P&Z CASE # SP2019-001 P&Z DATE _____ CC DATE _____

RE: SITE PLAN (SP2018-001), SUP for 7-11

Project Number: SP2018-001
Project Name: 7-11
Project Type: SITE PLAN
Applicant Name: VERDAD REAL ESTATE
Owner Name: PATMAN, CONNOR W JR
Project Description:

City of Rockwall Project Plan Review History

Electric Line Relocation Exhibit

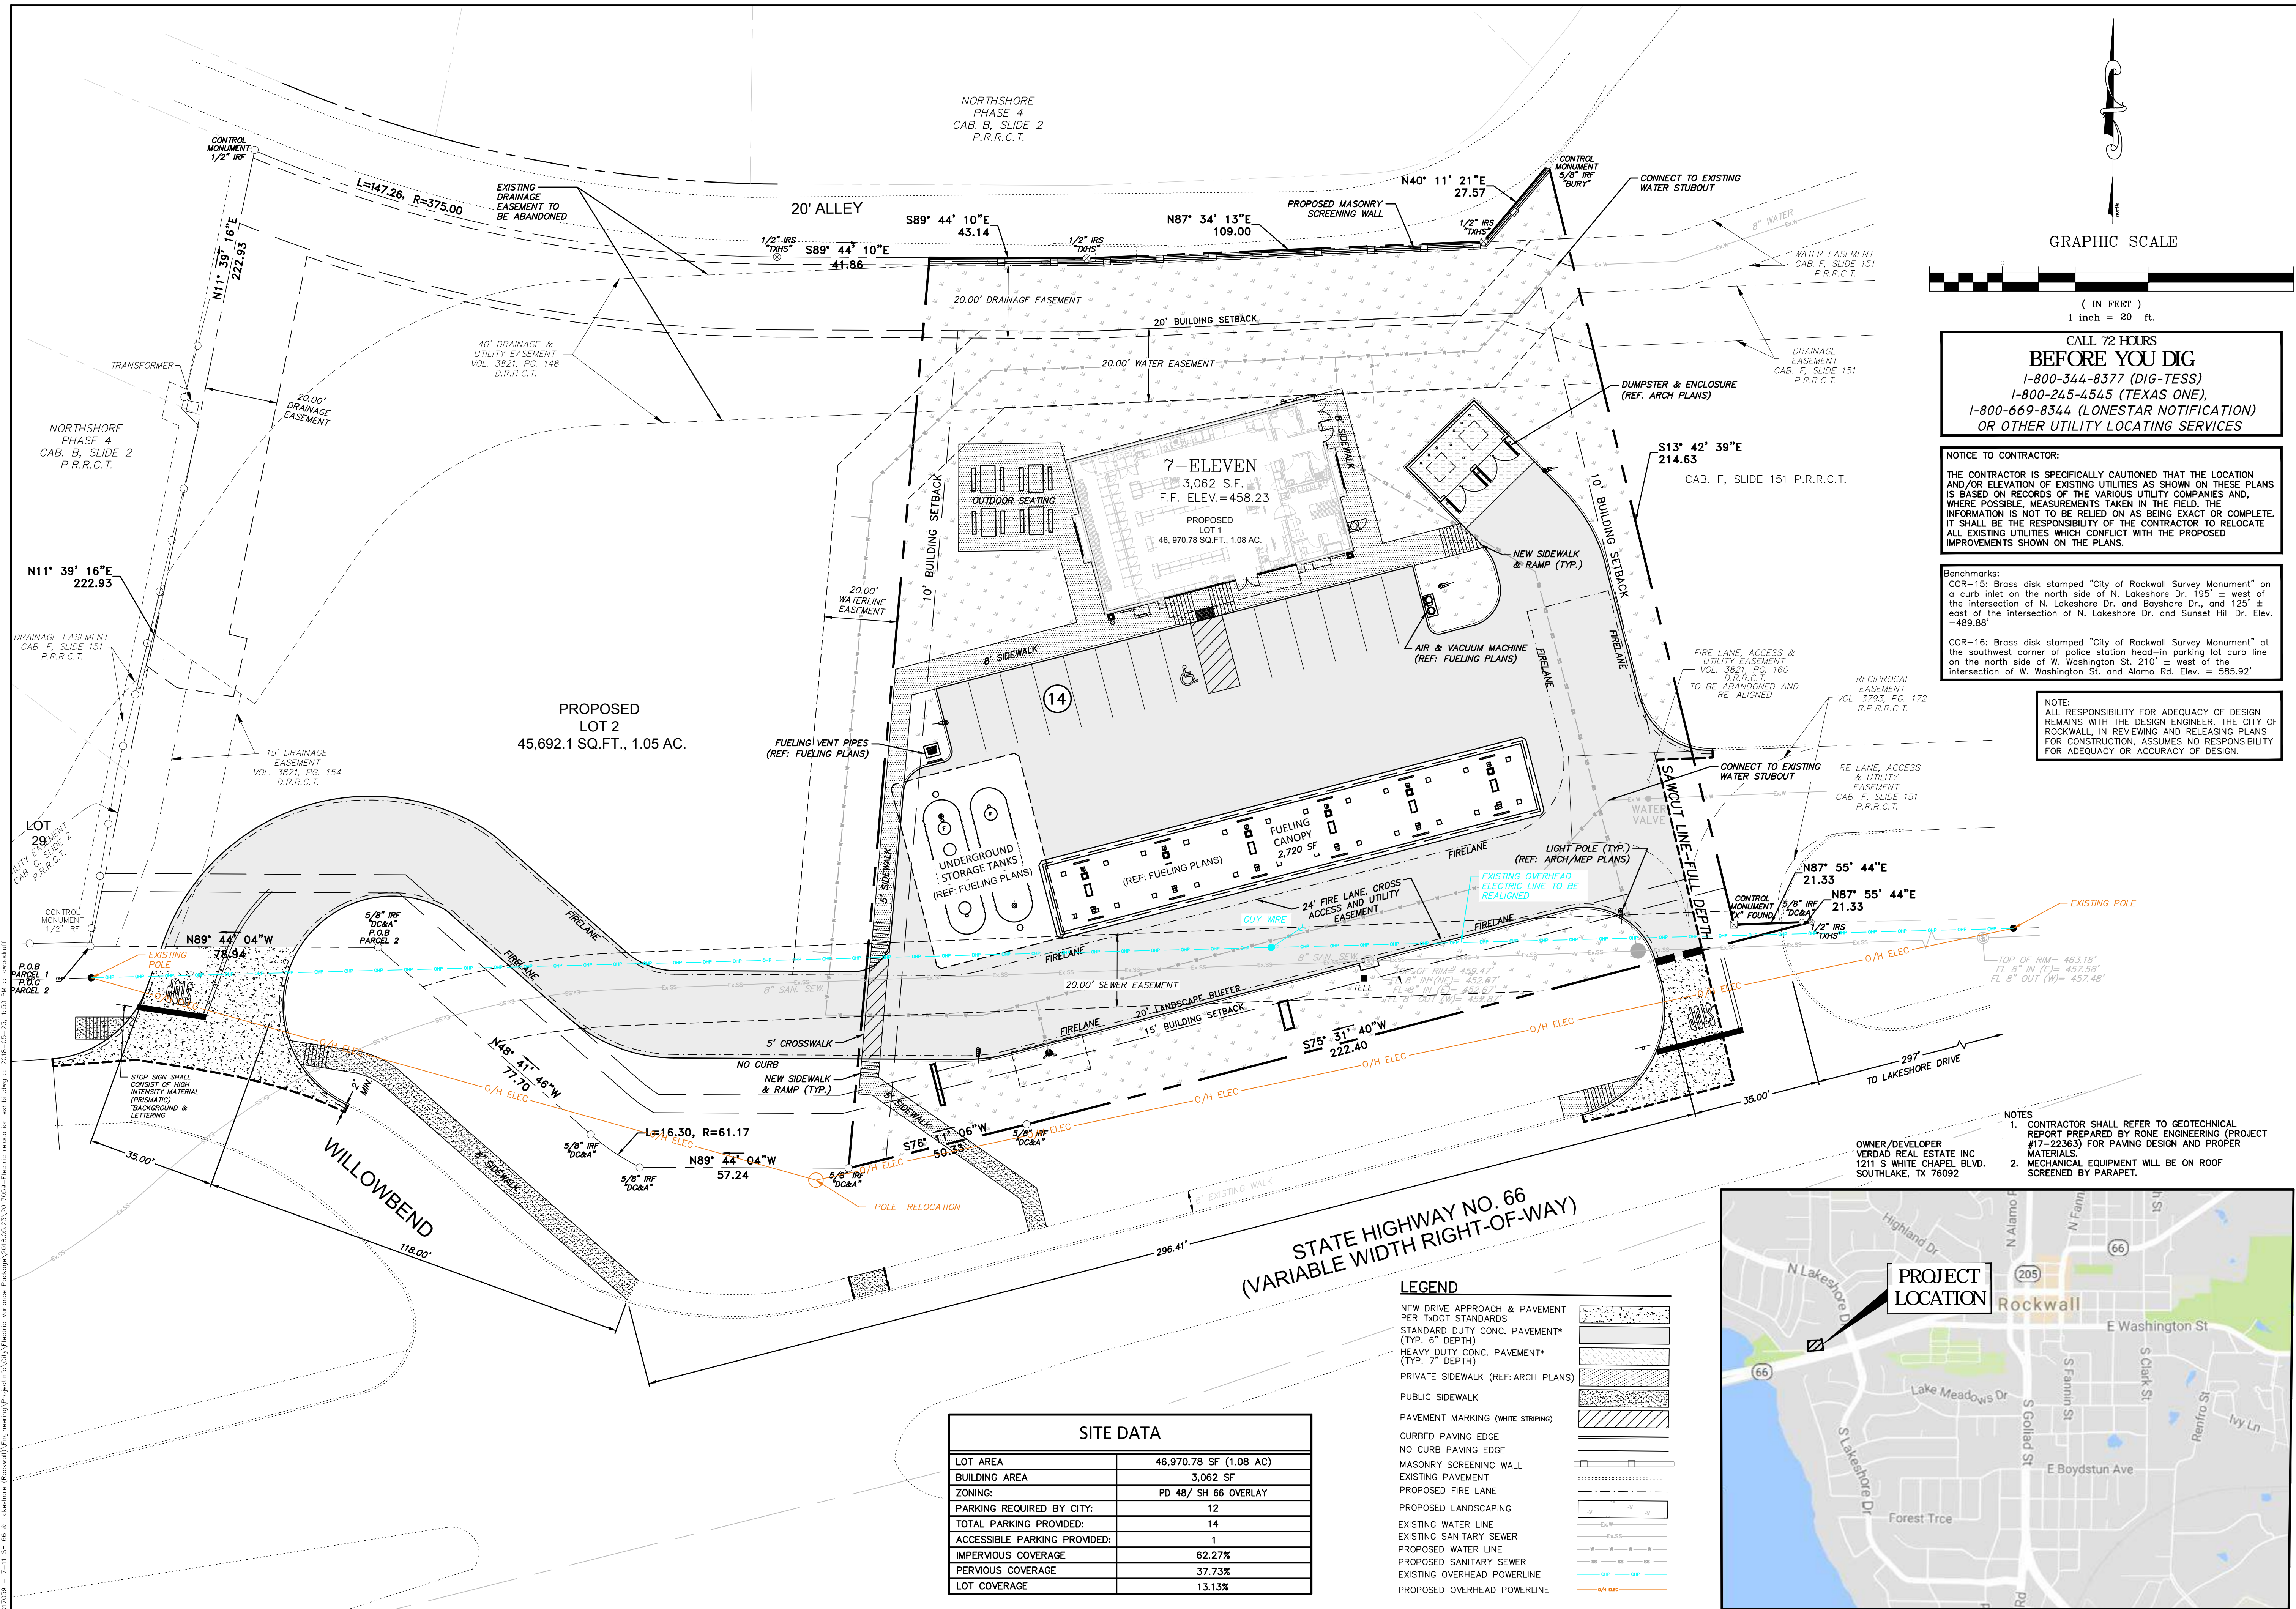
Since the site plan and variances were approved, the applicant has submitted civil engineering drawings and is working with the Engineering Department to address all comments. One of the issues that was identified through this process was a proposal by the applicant to relocate existing overhead powerlines from the interior of the site to the right-of-way line adjacent to the proposed landscape buffer. According to the City's ordinances, all relocations of existing overhead powerlines are required to be installed underground. This requirement is stipulated in several sections of the Unified Development Code (UDC) and Municipal Code of Ordinances. Specifically, the sections relevant to the subject property are as follows:

- ☑ Section 6.9, *SH-66 Overlay (SH-66 OV) District*, of Article V, *District Development Standards*, of the UDC:
 - I. Utility Placement. All overhead utilities within the SH-66 Overlay District shall be placed underground.*
